FINAL 2 MARCH 2022

Bankstown Master Plan Site Specific Review

Joint Panel Report

Figure 11: Elevation diagram demonstrating articulation principles to reduce visual bulk, i.e. base, middle and top horizontal articulation and vertical articulation

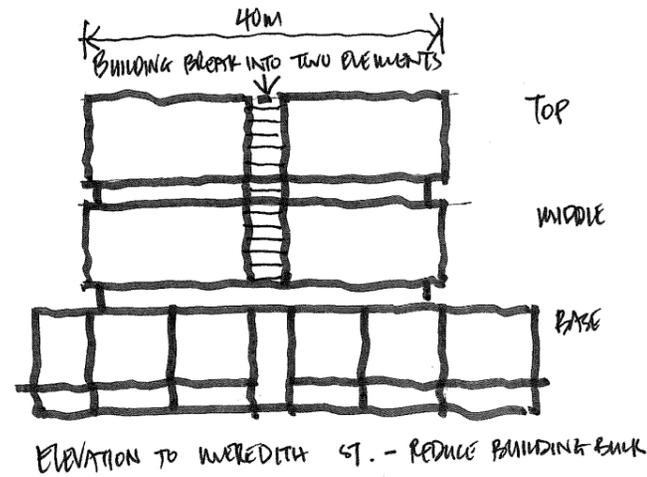
- Consider a rooftop garden on top of the mid-level volume of the building.
- Constrain excavated basement levels for car parking to the area beneath the building footprint, to allow deep soil planting in street setbacks and communal open space.
- Emphasise the corner with distinctive architectural expression.
- Incorporate vertical articulation to reduce visual bulk. Consider a layered built form which defines the base, middle and top of the building with deeper setbacks on certain levels. Refer to Figure 11 and Figure 13.
- Servicing and car parking access should be from Gordon Street only.
- The indicative floor plans indicate privacy and interface issues between some apartments in the mid-levels of the building which will require further design resolution. Refer to Figure 12.

Figure 21: Possible increased ground level setback for north facing street activity and laneway setback as per Tall Buildings Study.

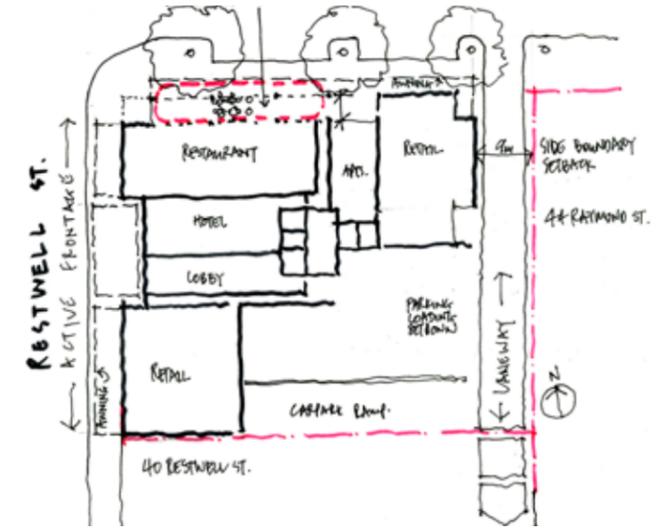
- Provide a minimum 9m setback to tower from the eastern boundary (6m from centreline of a new laneway) and a further 6m setback above 50m (15-16st), to articulate the top of the tower form and consistent with the Tall Building Study. Refer to Figure 21 and Figure 22.
- Protect the key active frontage classification for Restwell Street by removing the vehicle crossing and consolidating all vehicle and service access from Raymond Street, making use of the above 6m laneway.
- Consider an additional 3m setback at ground level of the north elevation (Raymond Street) for improved public benefit with a wider footpath, outdoor dining and greater tree canopy. Refer to Figure 21.

Figure 28: Plan view of simplified building forms

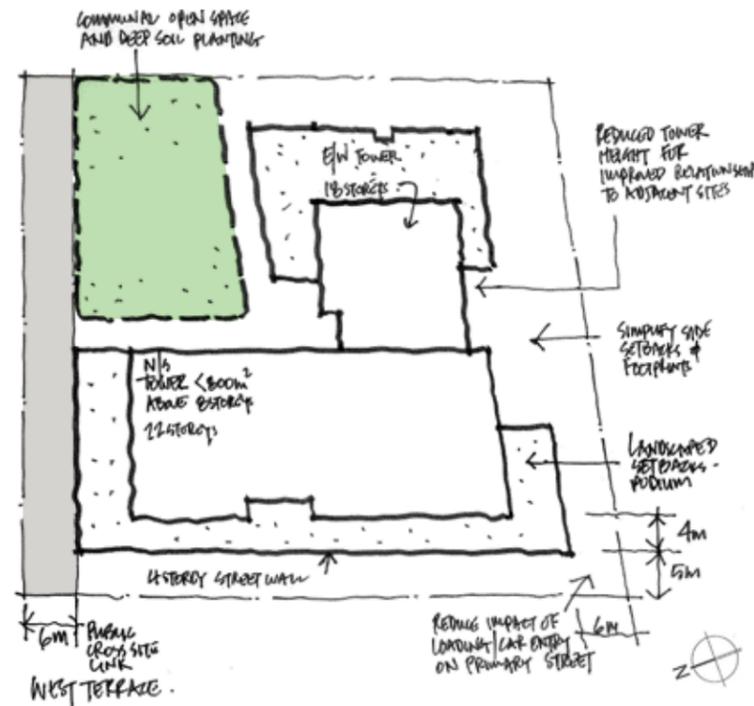
- Simplification of the tower into a single slab or bar building (refer to Figure 28) to resolve amenity issues associated with unit interface and configuration.
- Introduce a lower height for the east wing to articulate the built form, reduce bulk and potential overshadowing of adjacent building and pocket park to south east. Refer to Figure 29.

Figure 30: Design development is required to address privacy, amenity, bulk and visual appearance on the eastern elevation

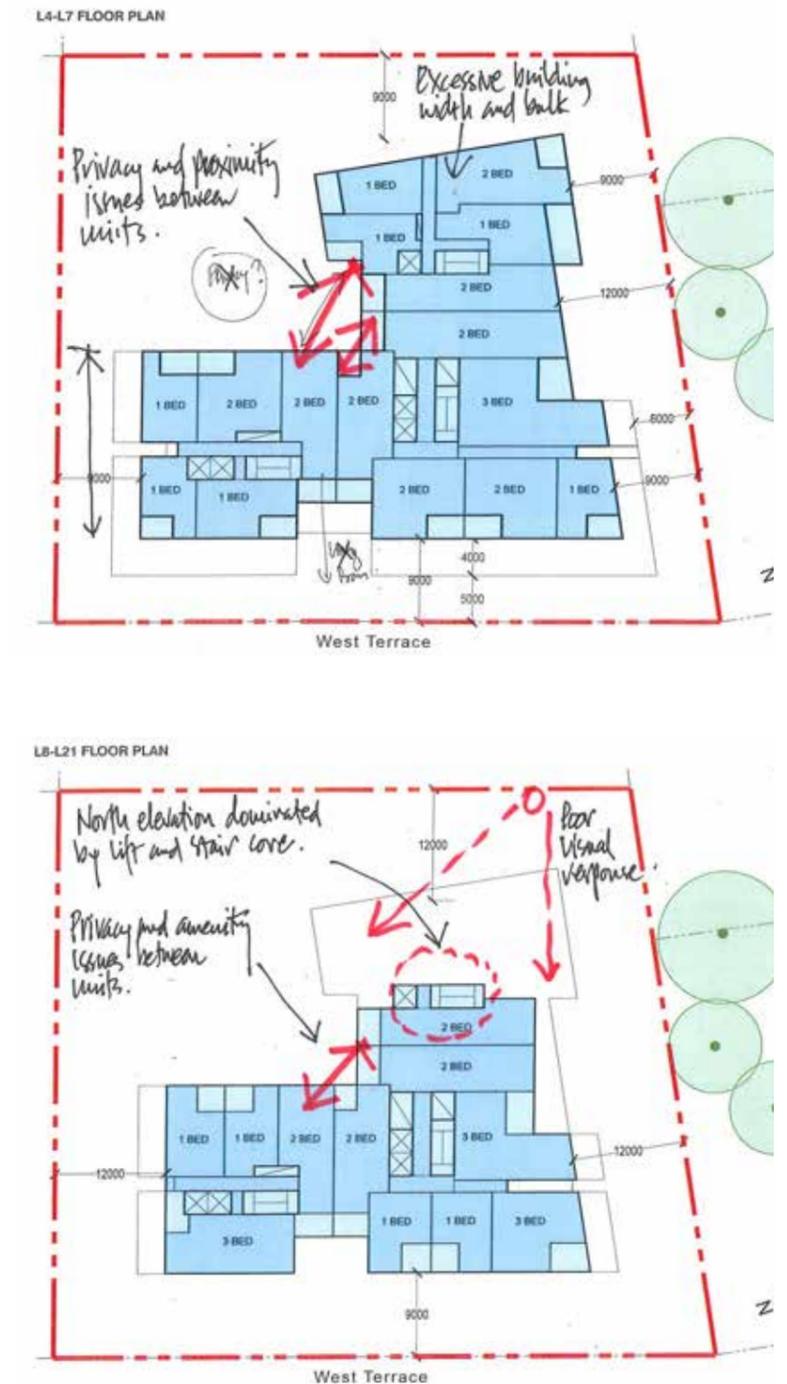
- Deep soil planting must achieve a minimum 7% of the site (283.m²) which is not shown in submission and will require some of the currently excavated site to be filled.
- Combined residential and commercial foyers should be separated for improved safety and amenity.

Figure 39: Potential to shift northern wing to the east (subject to shadowing impacts) in order to consolidate communal open space

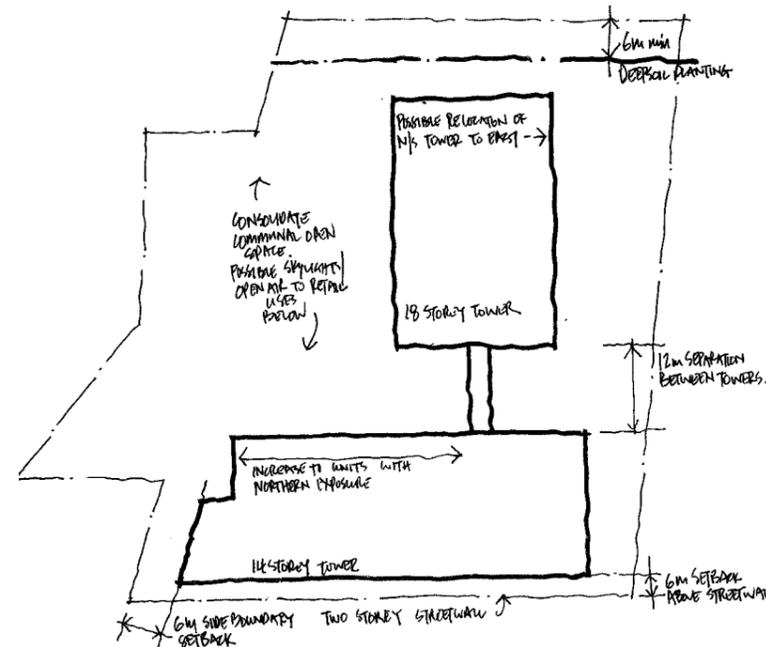
- A lower 14 storey height to the tower fronting Rickard Road
This would:
 - be more compatible with adjacent existing towers along Rickard Road;
 - serve as an appropriate height transition toward Paul Keating Park; and
 - would achieve a 4 storey staggered height to the rear tower to help modulate building bulk.
- Address the excessive building length to Rickard Road with well defined articulation, as indicated in the 3D modelling by the Proponent.

Figure 48: Building height transition diagram

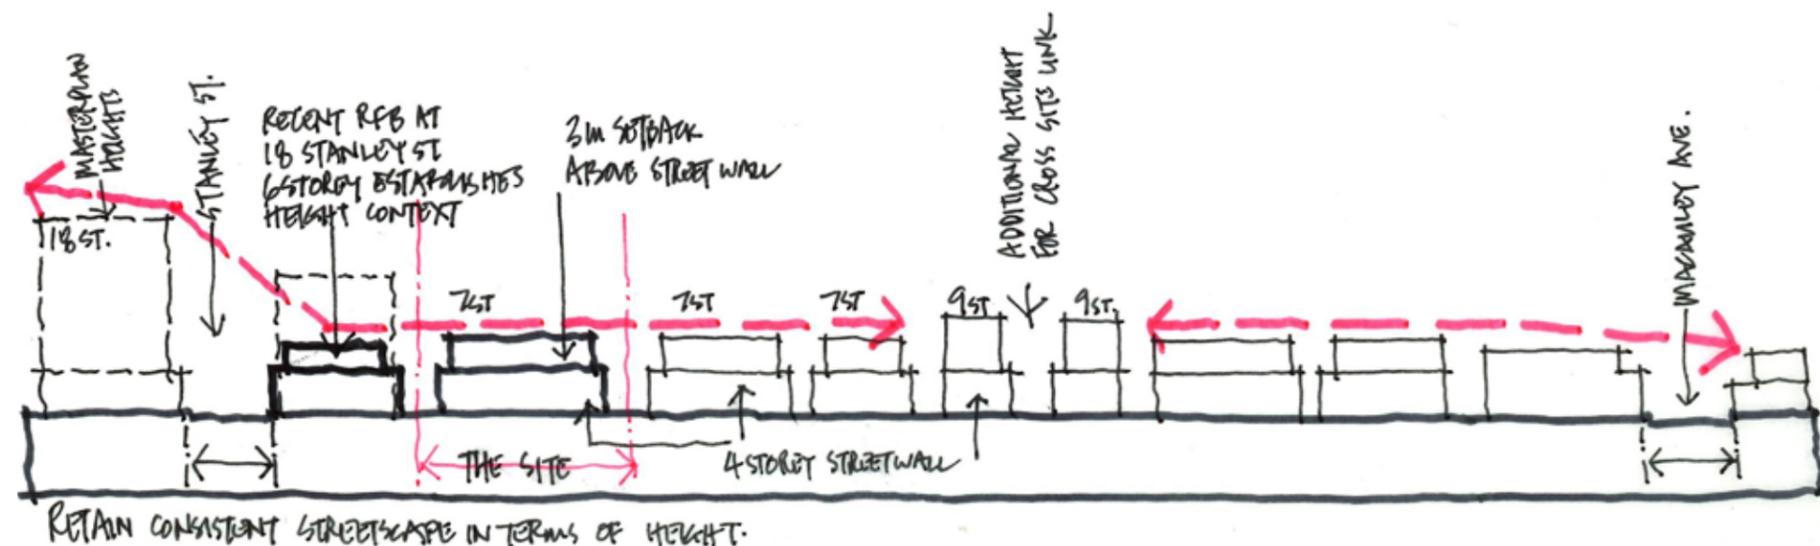
- Retain the 7 storey building height. Refer to Figure 48.
- Retain the 2:1 FSR.
- Allow a consistent 3m upper storey setback along the total length of the amalgamated block.

between the higher 13 and 18 storey Master Plan heights on Stanley Street to the north and the 7 and 6 storey forms to the south. Refer to Figure 48.
